PREPARED FOR THE URBAN DESIGN COMMISSION

Project Address: 849 E. Washington Avenue
Application Type: Alteration to a development in UDD 8
Legistar File ID # [59005](#)
Prepared By: Janine Glaeser, UDC Secretary

Project Description: The applicant is seeking approval for an exterior alteration to an existing building in Urban Design District 8 (UDD 8). The proposed work includes changes to the exterior windows and the addition of an outdoor 20 +/- seating patio dining area.

Deck height graphic

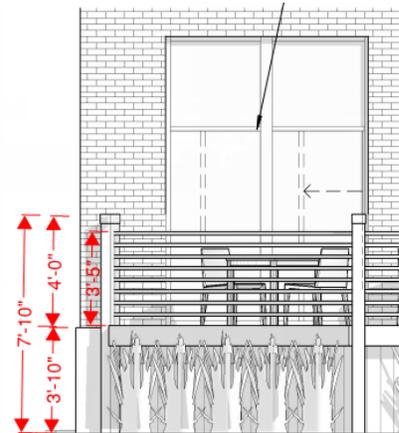
Staff’s primary question with this request is whether the proposed porch addition can be found to meet the standards of UDD 8. Specifically, the Building Location and Orientation Requirements of UDD 8 (MGO Section 33.24(15)(e)1a.) require a **15-foot front setback** for new buildings and additions.

The existing building is set back approximately 11 feet from the sidewalk and the proposed porch would then extend out to the sidewalk. The floor of the porch has a height of approximately 3 feet 10 inches and over seven feet in height with the rails. Staff understands that the proposed porch and rail height are based on meeting ADA requirements for access to the deck from inside the restaurant. There is no public access to the deck from the sidewalk.

The UDC has the ability to grant larger setbacks for the purpose of allowing additional public open spaces; however, staff does not believe that provision is applicable here as it does not speak to possible setback **reductions**. Staff notes that the UDD 8 guidelines state that building location should be designed to provide for amenities that will enhance the visual and pedestrian character of the street. While many developments approved in UDD 8 have patio areas, staff cannot recall one that included one with this much height and mass in the setback area.
